Date: September 7, 2023  
To: TRPA Hearings Officer  
From: TRPA Staff  
Subject: Single-Family Residential Rebuild for North Shore TVCA LLC,  
6650 North Lake Boulevard, Tahoe Vista, Placer County, CA; Assessor's Parcel  
Number (APN): 117-072-006; TRPA File No.: ERSP2023-0707

**Requested Action:**

**CIVIL AND BMP DETAILS**  
**ROADSTER, LLC**  
 6650 NORTH LAKE BOULEVARD  
 APN 117-072-006  
 PLACER COUNTY  
 TAHOE VISTA

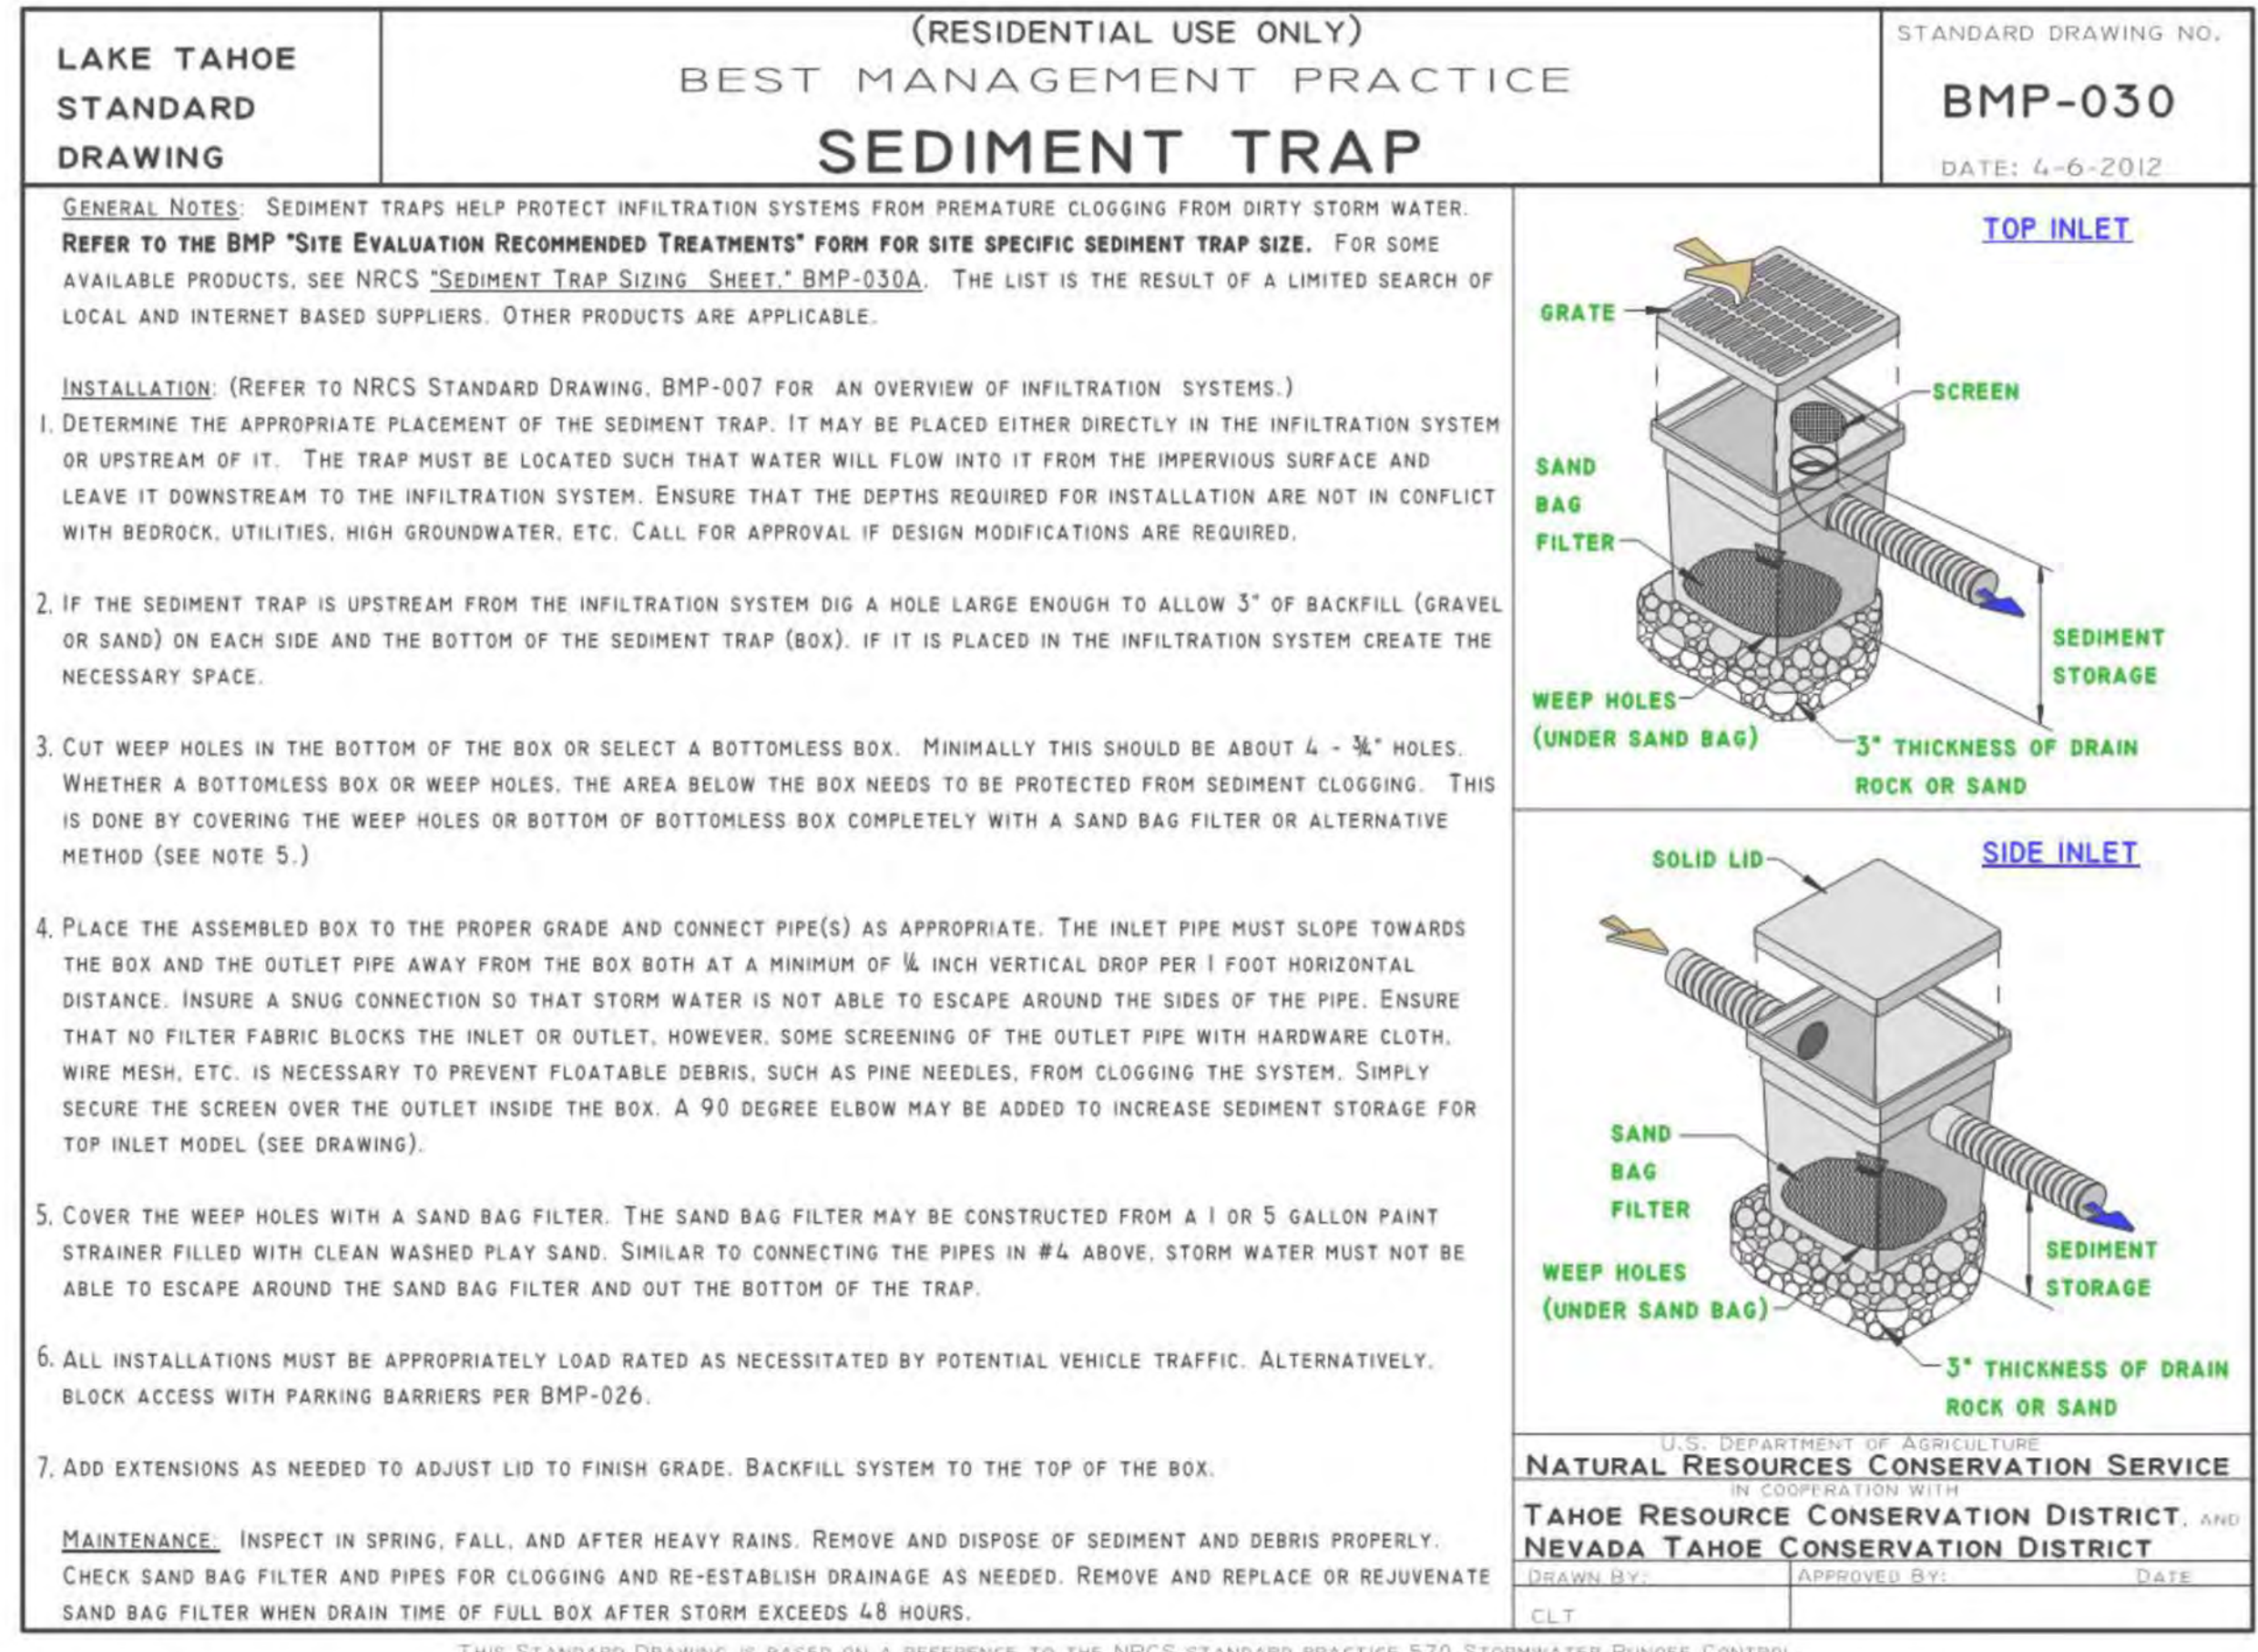
- (10) Enhance driveway BMPs with 3 cleanable sediment traps (detail 2/C2.2) located at 2 points along treatment P and where treatments P and M meet. Provide driveway edge armor (3 inch deep by 12 inch wide infiltration trench or suitable alternative) adjacent to the driveway edges that do not have BMP treatments. Expand armor width to the toe of slopes adjacent to the driveway.

**ENLARGED SITE PLAN**  
1/8" = 1'-0"

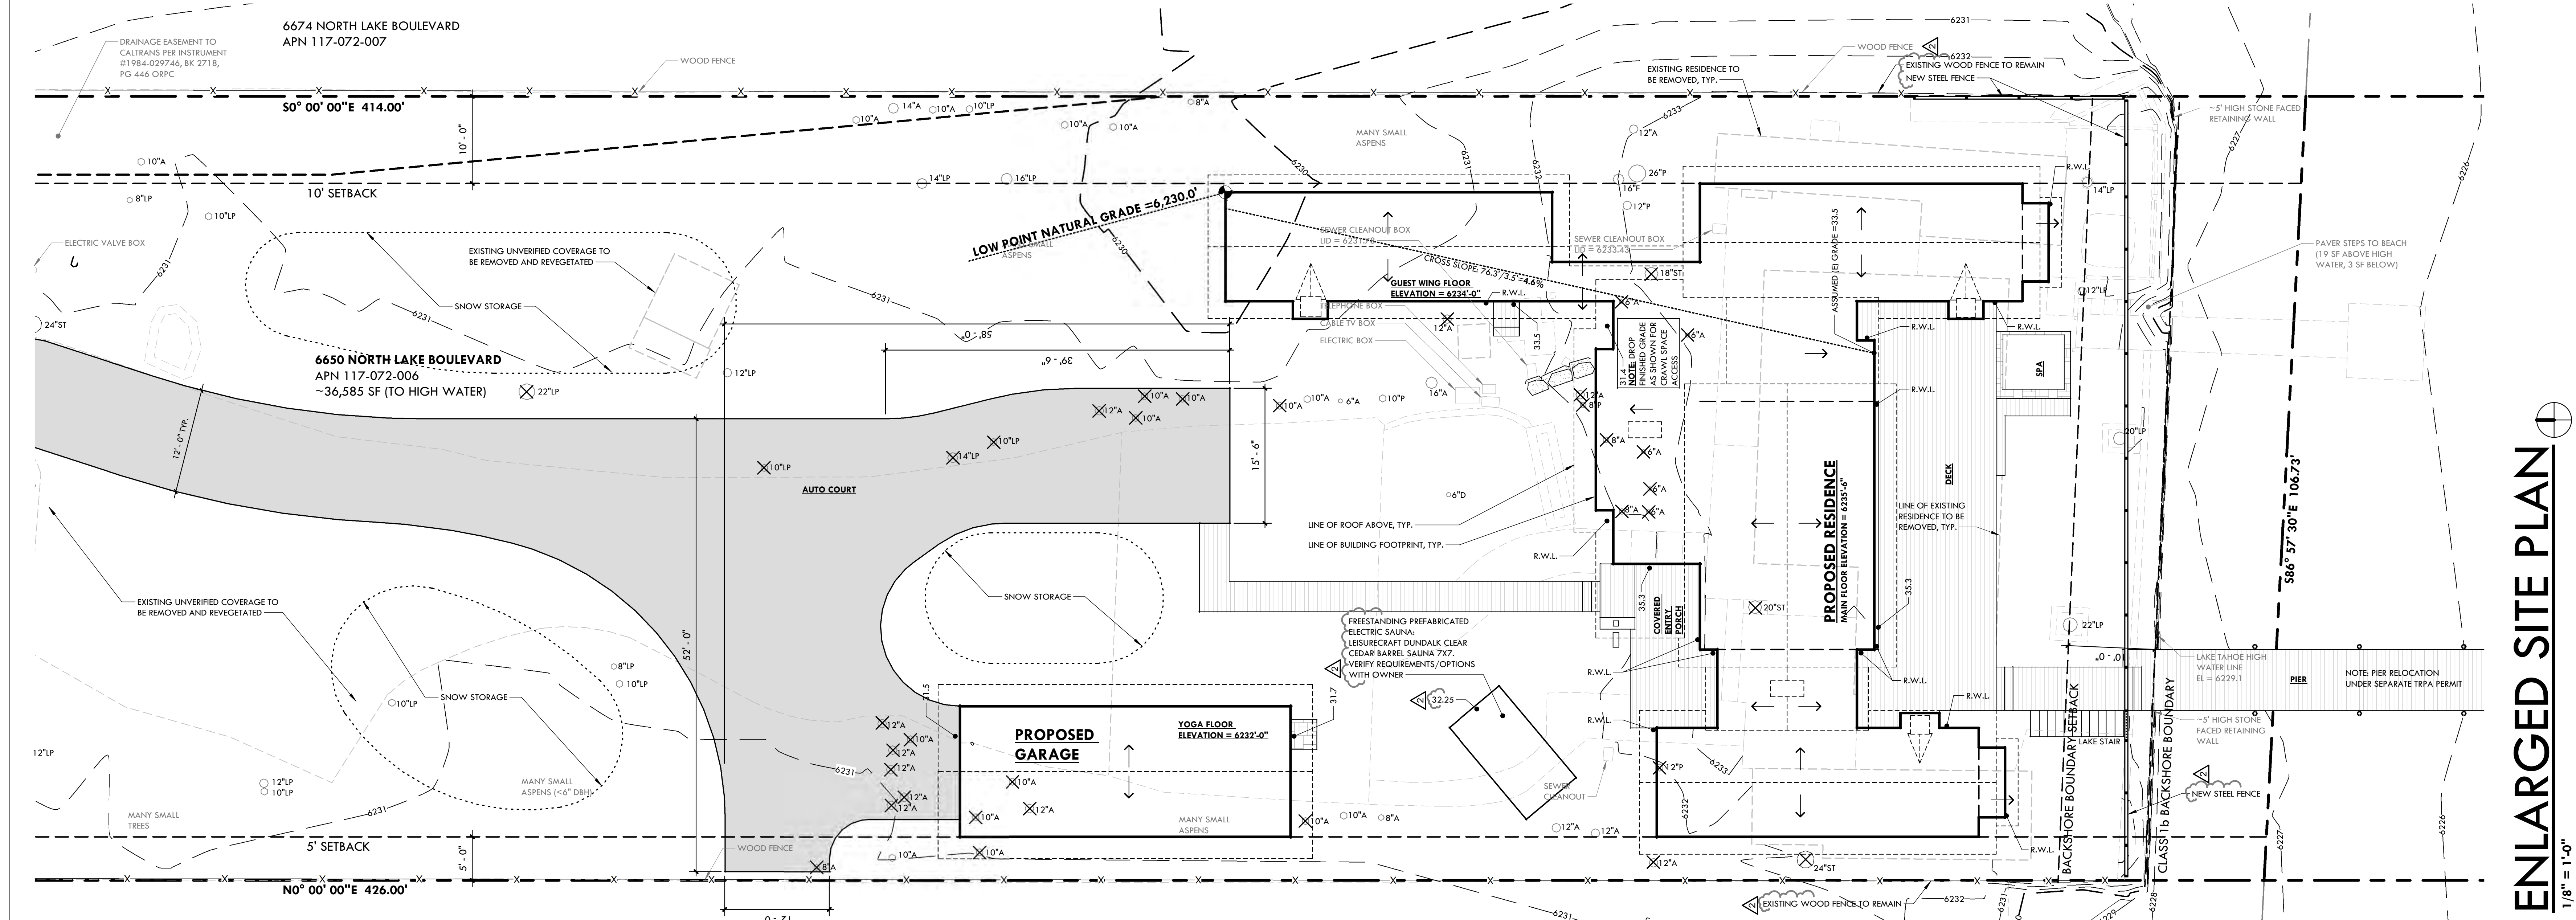
- (4) Indicate staging areas for construction equipment and materials.
- (5) Modify drawings and notes for shorezone improvements. Depict and label existing and planned beach stairs. Depict and label the relocated opening in the retaining wall / breakwater that will be required. Add a prominent note for shorezone improvements: "Note: Plans depict shorezone improvements including relocated pier, beach stairs, and opening in the retaining wall / breakwater. These improvements reflect property owner plans for a future shorezone permit application and are not approved with this permit. A pier relocation or demolition/banking permit shall be issued prior to final inspection. Separate permits are required for any improvements in the shorezone, except repair of the existing retaining wall / breakwater." Add the same note on the site plan (sheet A1.1).

**LAND COVERAGE DIAGRAM**  
1/16" = 1'-0"

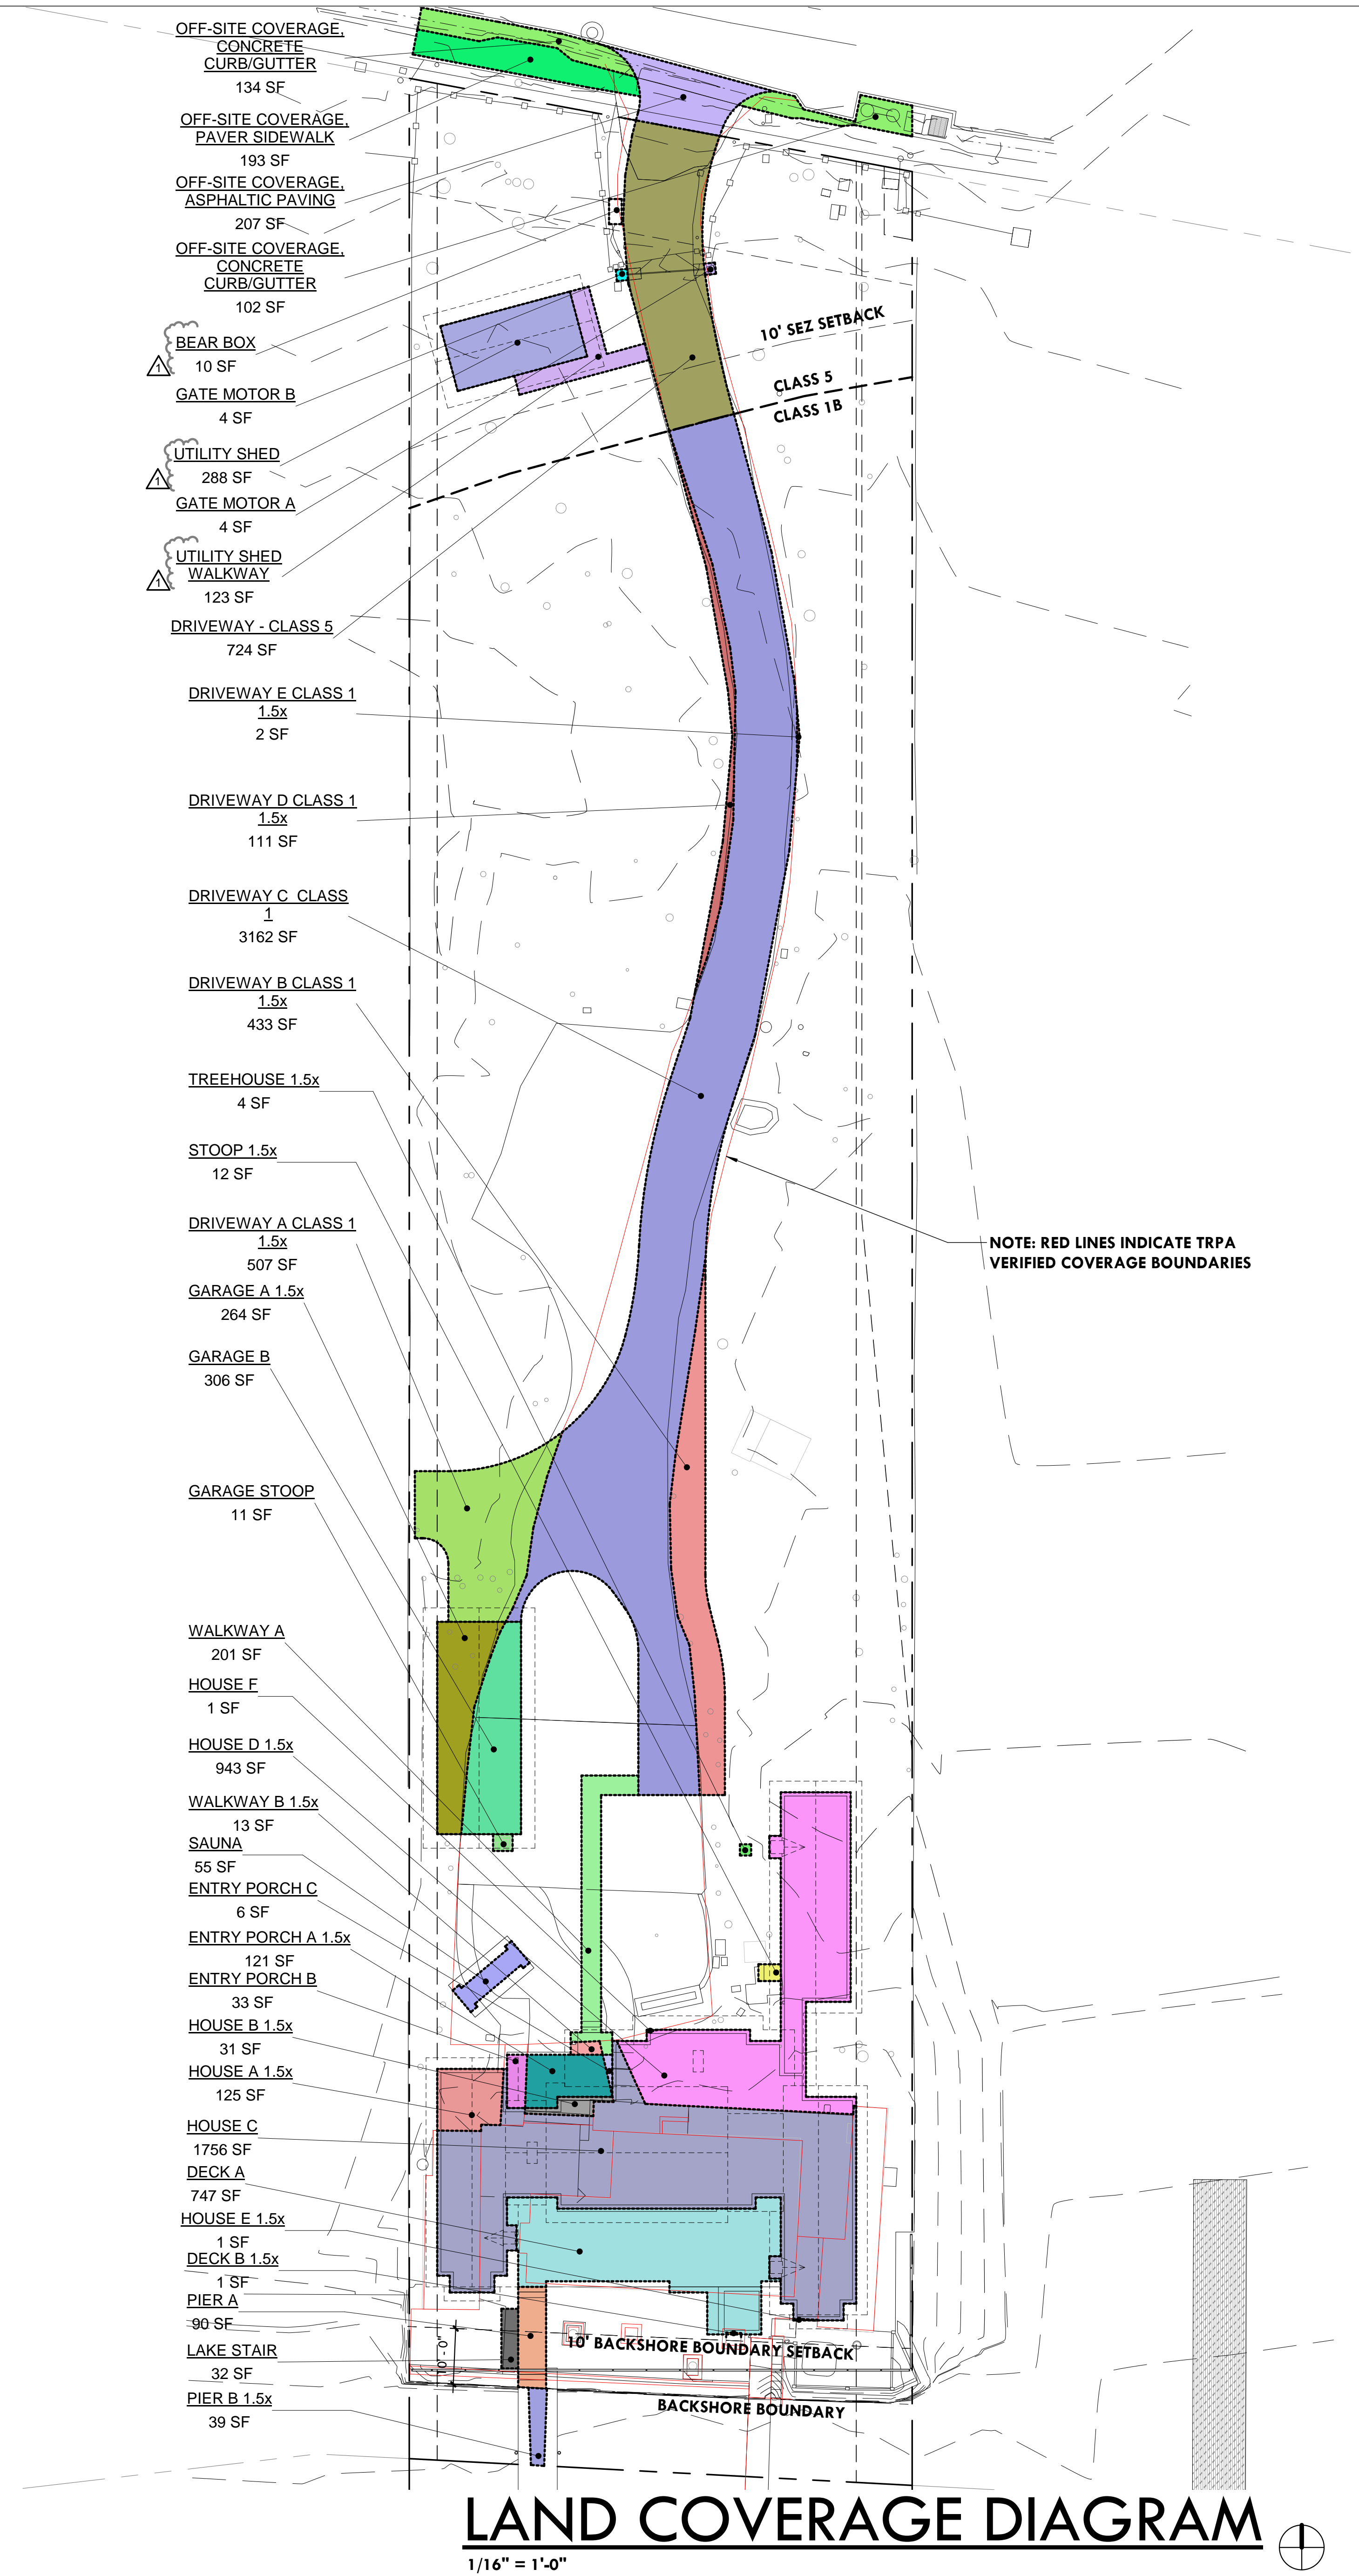
- The coverage plan (sheet A1.2) shall be revised to include the following:
  - (1) Updated coverage calculations as follows:
    - (a) Round coverage totals to the nearest whole number. 10,311 square feet of class 1 coverage is used, with none banked.

- (b) Change “coverage to be banked” section to “coverage available for future use” and update class 1b to have 0 square feet available.
    - (c) Add excess coverage information. There is 9,995 square feet of excess class 1b coverage, with none previously mitigated.
